HIAWATHA GOLF & PLAY

WATER MANAGEMENT CONCEPT **ALTERNATIVE 6**

The Bronze Foundation is pleased to present a water management design for historic Hiawatha Lake and Golf Course. It improves flood protection, reduces groundwater intrusion into neighborhood basements. It also will improve Lake Hiawatha water quality for swimming, and prevents problems associated with creating a second lake on the existing protected site.

▲ **Figure C.** MPRB Master Plan (2017) aerial-view and cross-section. Aerial view shows seasonally flooding and permanently wetting an area about the same size as Lake Hiawatha.

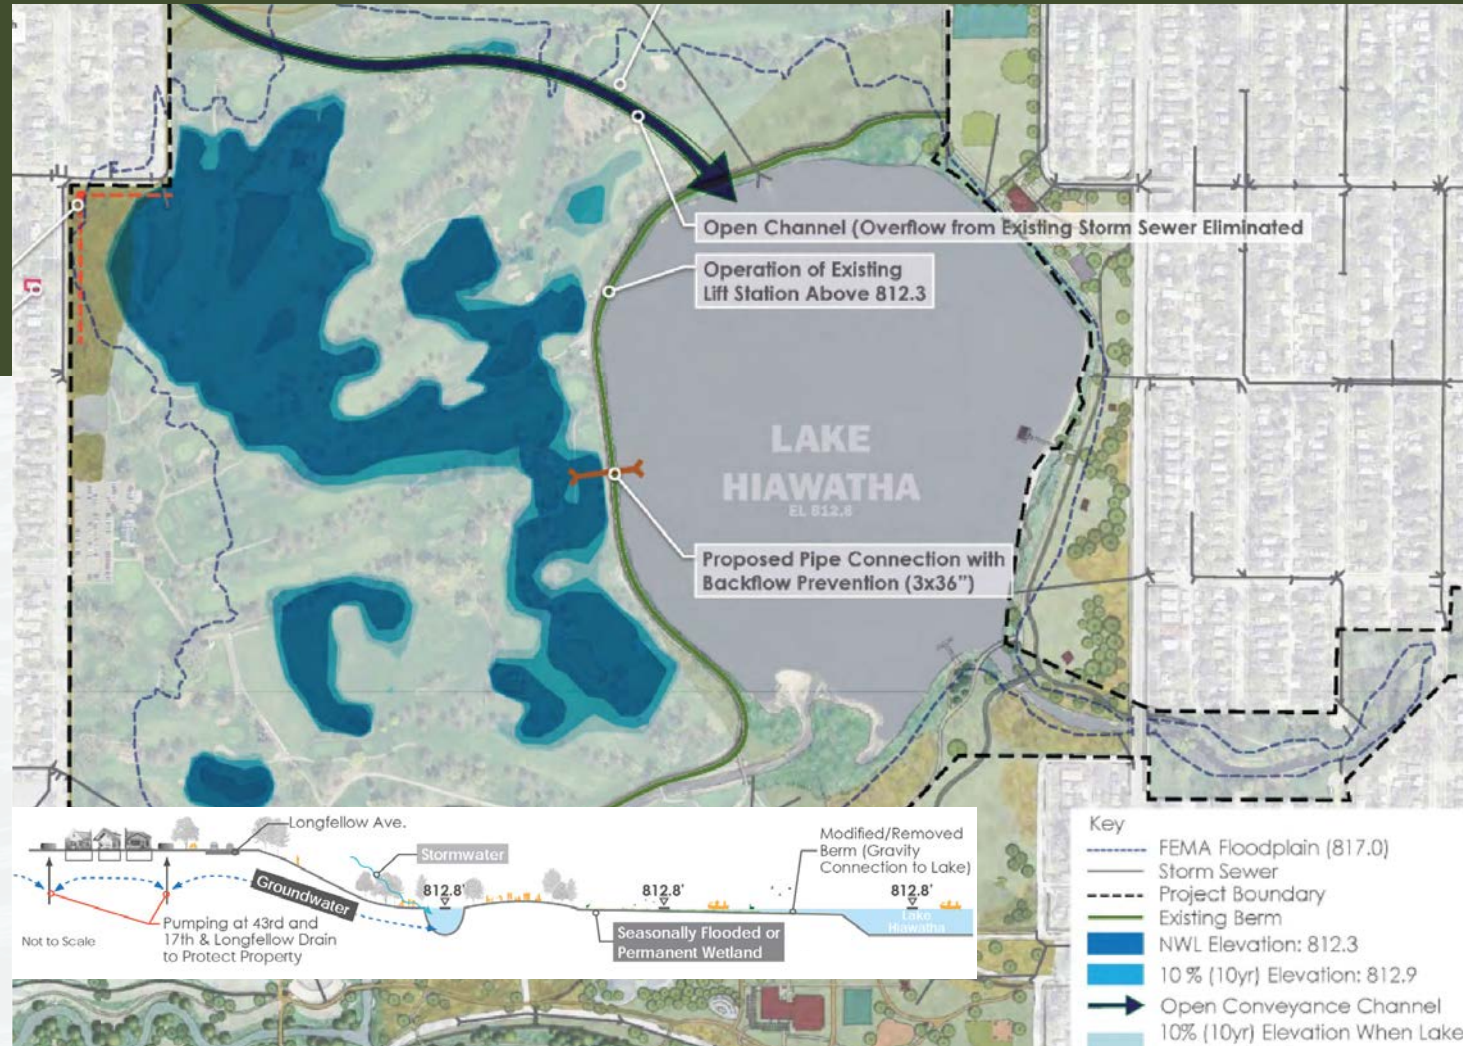
The MPRB Master Plan would effectively raise the water surface elevation during both dry and wet weather conditions. The proposed solution would increase and hold the water surface elevation at $\geq 812.8'$ which is above historical floodwater elevations in both Lake Hiawatha and the proposed 50 acres of new permanently wetted area west of the lake.

▲ **Figure D.** 90 homes, northwest of the Hiawatha Basin, lower than 820' elevation, outlined in yellow, will be subject to flood risk with the Master Plan Concept due to higher peak flood water elevations.

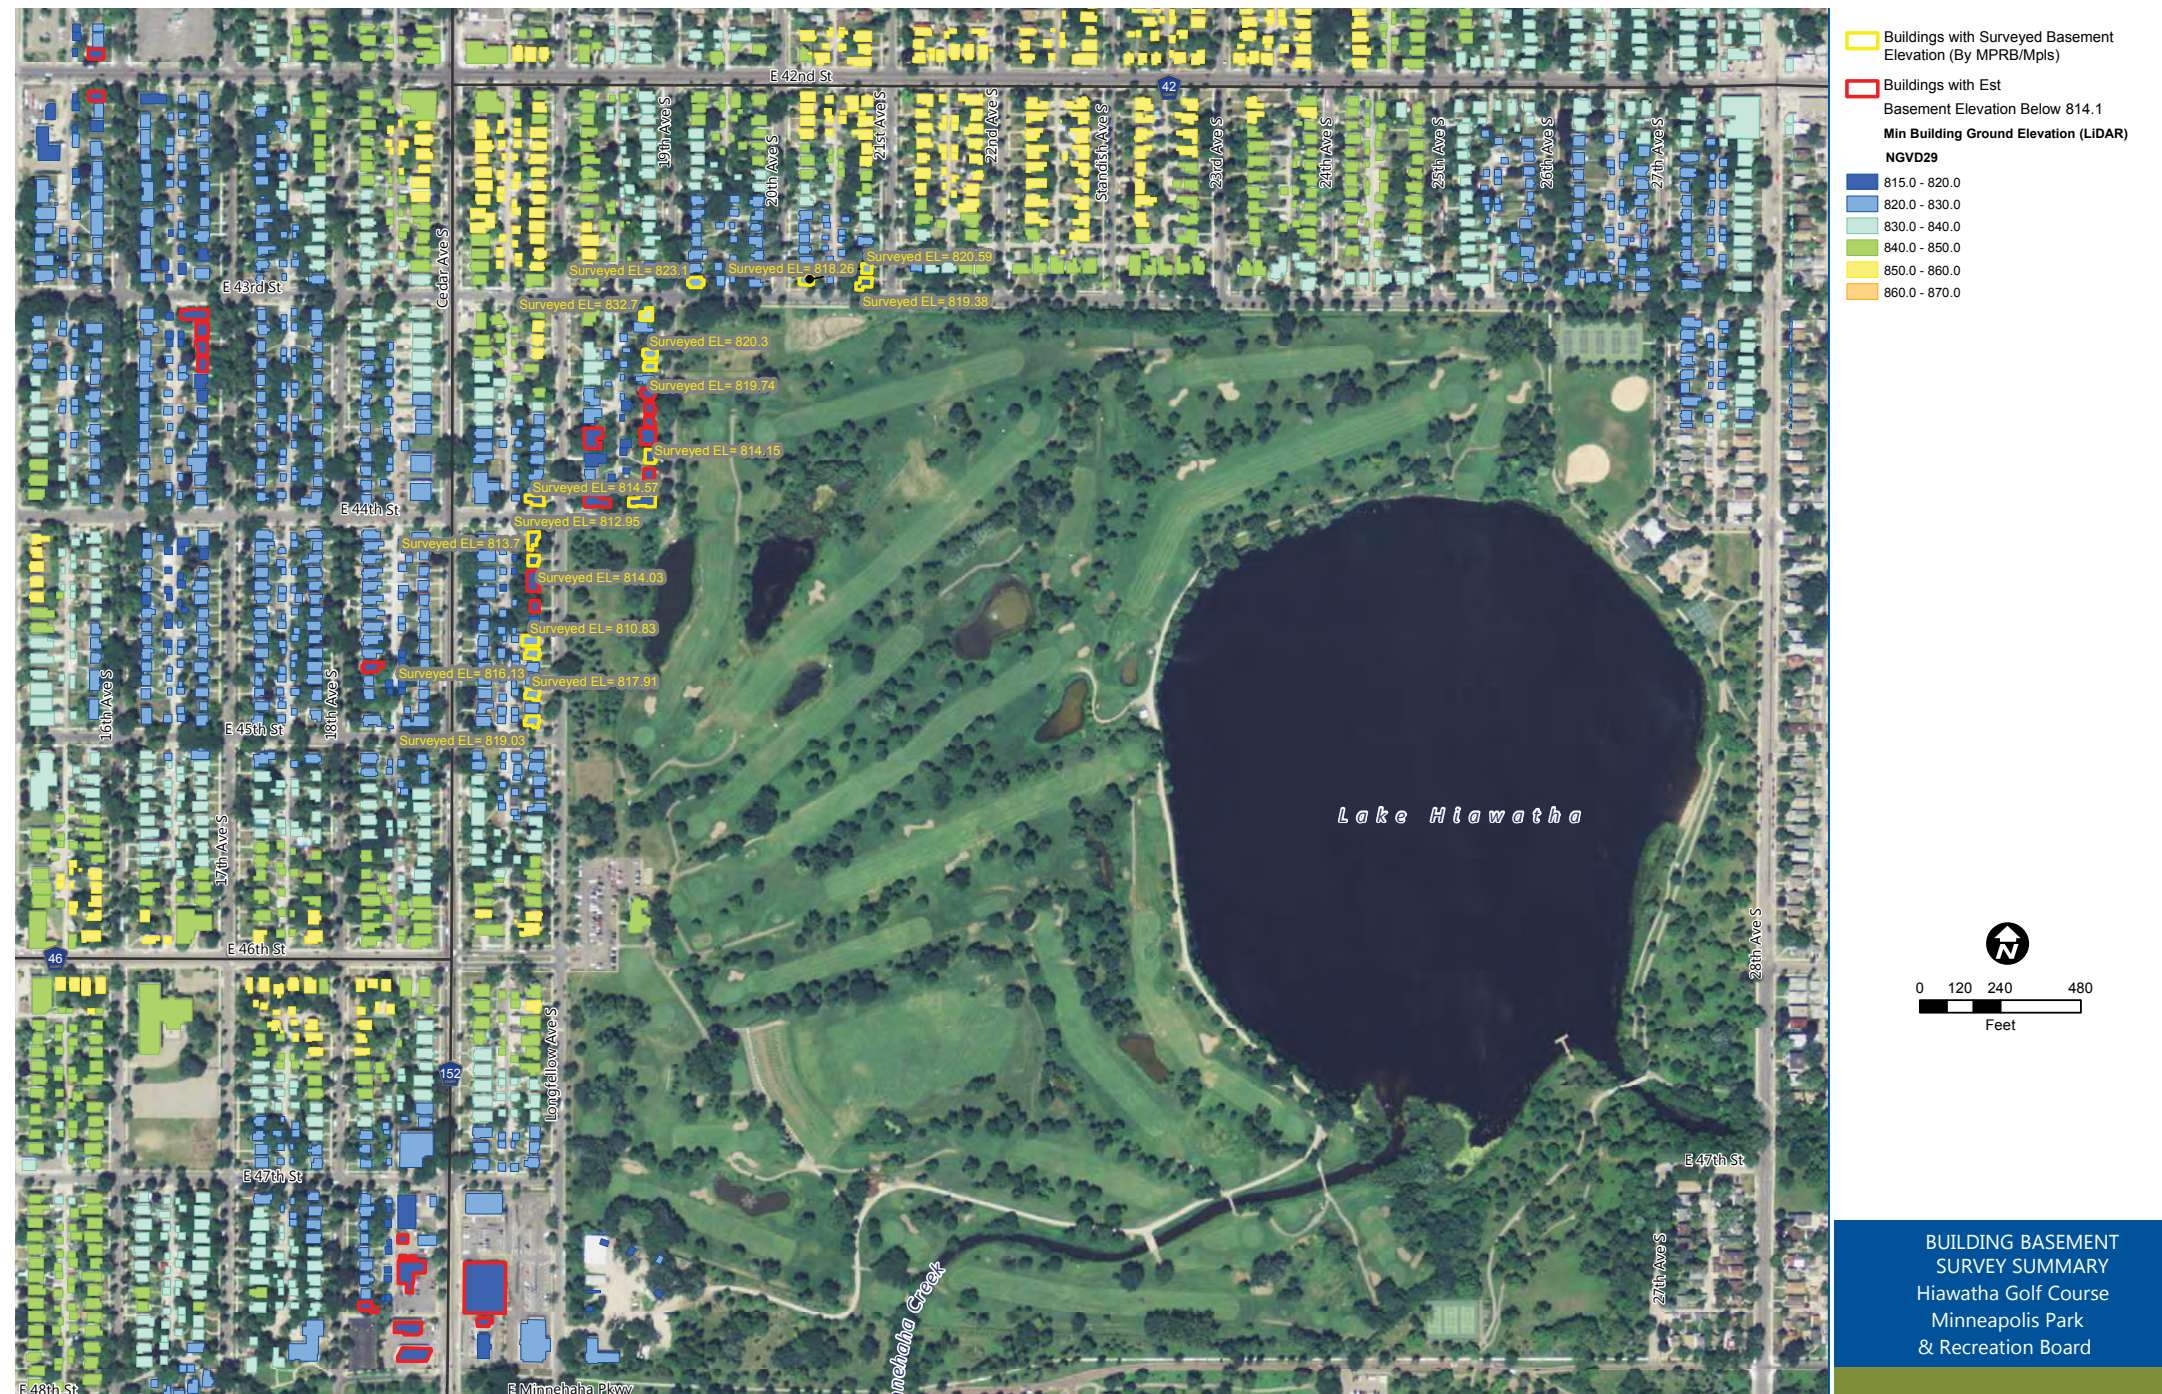
In the existing conditions, working for decades, stormwater inflows all enter the lake and are conveyed downstream to the Mississippi River. When high inflows exceed the downstream capacity, the lake fills up until it overflows the berm into the golf course at elevation 814.5' (about 3 feet higher than dry weather conditions). During these floods, about once every 10 years, the golf course's lower elevation provides an important function to reduce peak stormwater volume, below critical levels. In the proposed Master Plan Concept the berm between the lake and the golf course bowl would be removed, and the golf course floodplain would be flooded already. Stormwater from the beginning of a storm will be discharged at a lower flowrate because the water elevations of Lake Hiawatha and the new 50-acre wetland won't increase initially as fast as the existing condition. Floodwater may push further westward into residential areas.

Stormwater at the beginning of a storm fills the new wetland/lake before the peak of the storm event. When the peak of the storm event arrives, XPSWMM (Stormwater Wastewater Management Module by Innovyze) **shows the peak wet weather water surface elevation will actually increase with the Master Plan Concept.** Unfortunately, there are 90 homes northwest of the park situated at low elevation ($<820'$) that may be more susceptible to property damage from surface water flooding if the golf course water surface exceeds the existing peak water surface elevation of $\pm 817'$.

▲ **Figure E.** 500 Homes, shown in turquoise and blue, subject to groundwater intrusion into their basements with removal of the Lake Hiawatha berm, increasing groundwater elevation from 810' to 813'.

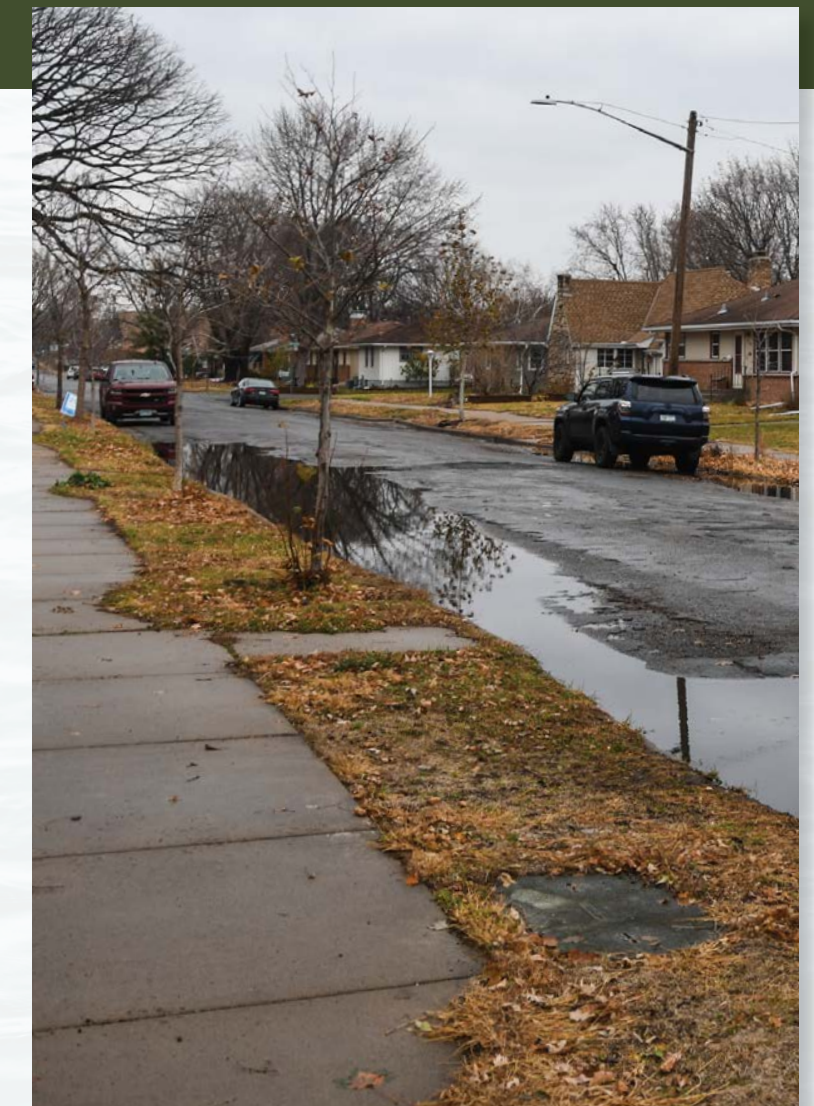
The regional groundwater table elevation is currently maintained at about 810' above sea level. Because most homes are situated at elevation 820' or higher, basement floors are approximately 813' elevation. Pumping from Pond E helps keep them dry from groundwater intrusion. In the proposed Master Plan, the groundwater elevation will no longer be maintained at elevation 810'. It will be about 812-813' during normal dry weather conditions. Considering hydraulic slope around the park, the Master Plan Concept groundwater elevations near surrounding homes will be higher than the floors of many basements. Additional groundwater intrusion is likely to occur for more than 500 homes.

▲ The Master Plan Concept proposes "Shallow Lake Hiawatha #2" west of Lake Hiawatha. This will reduce park land from 186 to 131 acres and be subject to nutrient overload, nuisance mud, odors, and vectors from fluctuating shallow water.

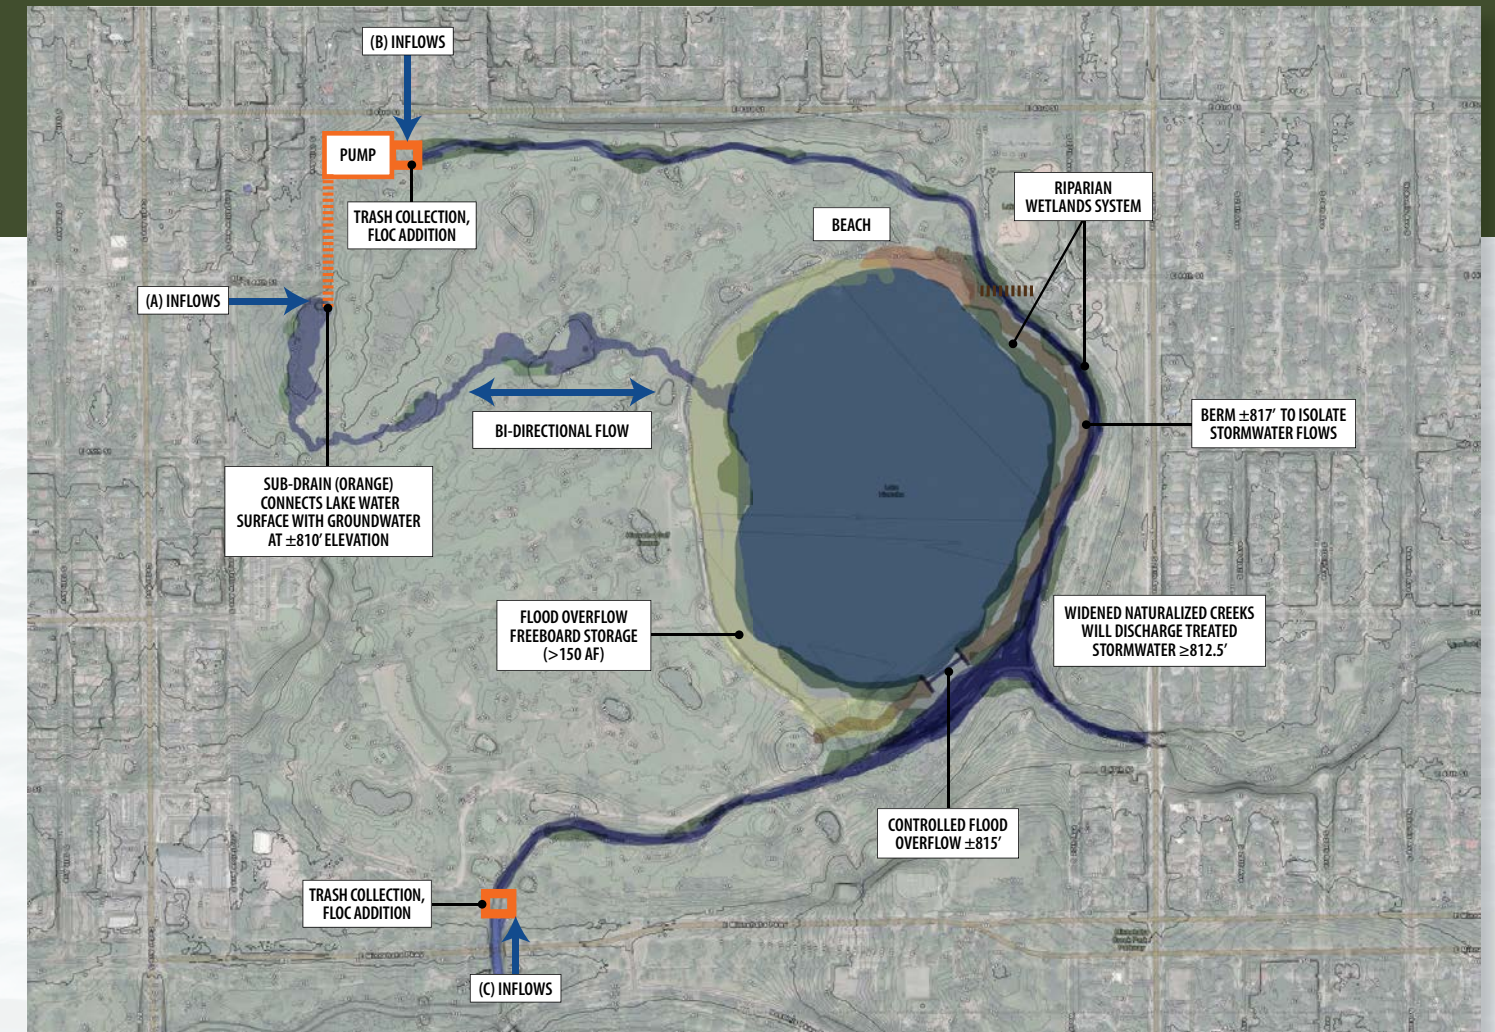
Of the 241-acre Lake Hiawatha Park property, Lake Hiawatha covers 55 acres. In the Master Plan Concept a second shallow Lake Hiawatha of 55 acres would be created, thus reducing valuable urban green-space from 186 acres (241 acres – 55 acres) to 131 acres (186 acres – 55 acres). Because the water surface elevation of Minnehaha Creek is so variable, with changes of several feet in monthly water surface elevations, the proposed shallow wetlands will dry out and expose shoreline mud and muck. This "wetland" will turn stagnant, odorous, and attract vectors, including mosquitoes.

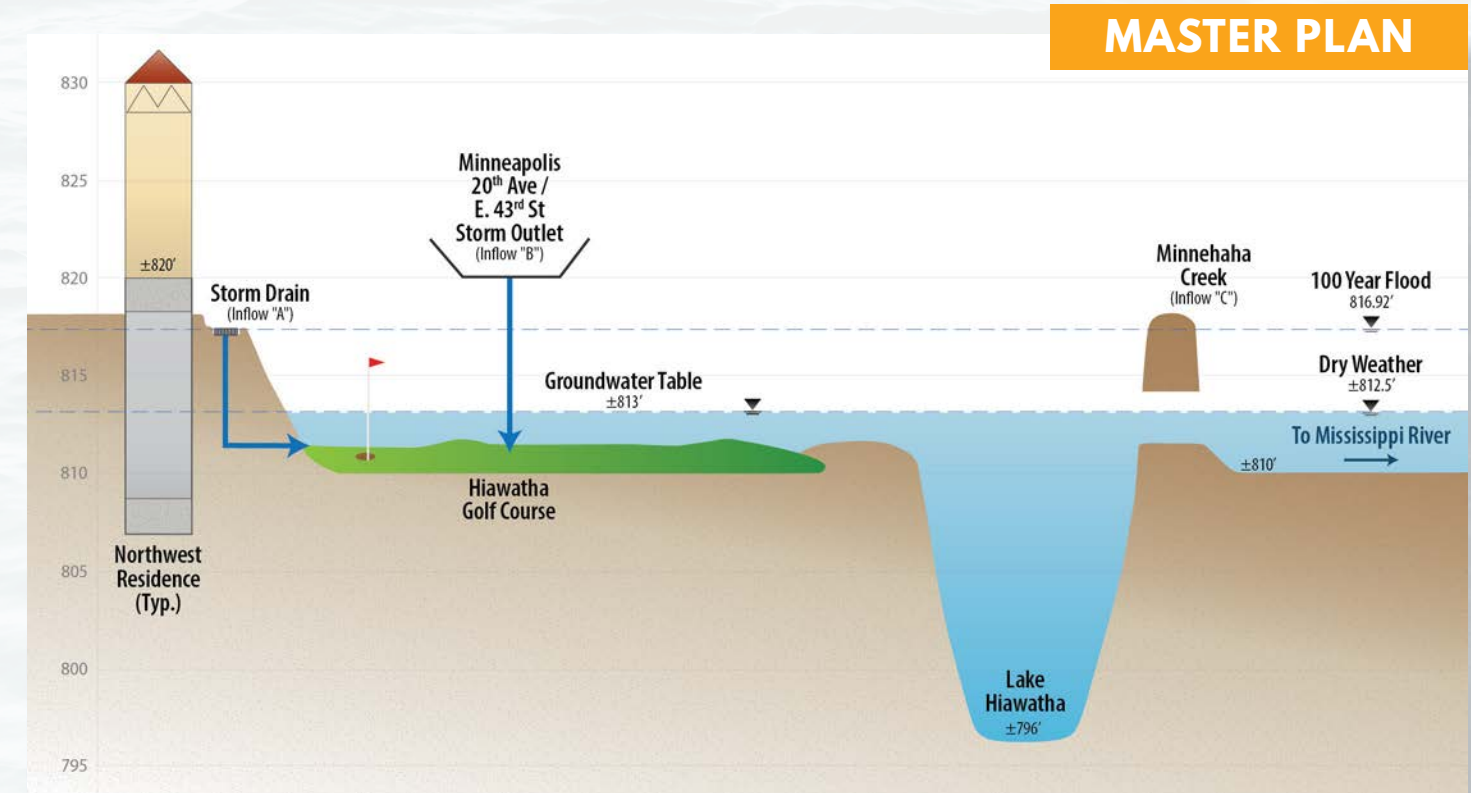
▲ **Figure I.** The MPRB Master Plan Concept permanently wets and seasonally floods a large portion of existing dry park land. The wet weather floodwater elevation will be worse than the existing condition, according to our XPSWMM results. Groundwater elevations will increase 3 feet, subjecting 500 basements near the Lake to flooding. The golf course area is permanently/regularly flooded.
